DOCUMENT CHANGE REQUEST

DCR number 470	Changes required for: General	Originator: Steve Thacker - ESCC
Date: 2009/02/06	Date sent: 2009/02/06	Organisation: ESA/ESTEC
Status: IMPLEMENTED

Title:	Resistors Fixed Chip Thick Film Based on Type CHP		
Number:	4001/026	Issue:	2

ESCC Detail Specification No. 4001/026

1.6 PHYSICAL DIMENSIONS

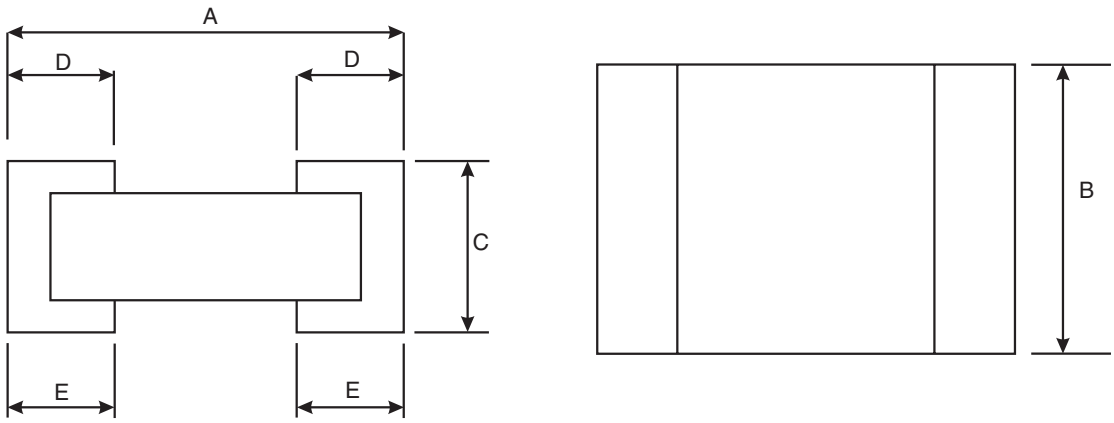
In line with Maunfacturer (Vishay SA Sfernice/France) request, new Variants 06 to 10 with 'E2' terminal material & finish are added (otherwise identical to Variants 01 to 05 respectively).
Paras 1.4.2, 1.5, 1.6, 2.4 are amended accordingly.
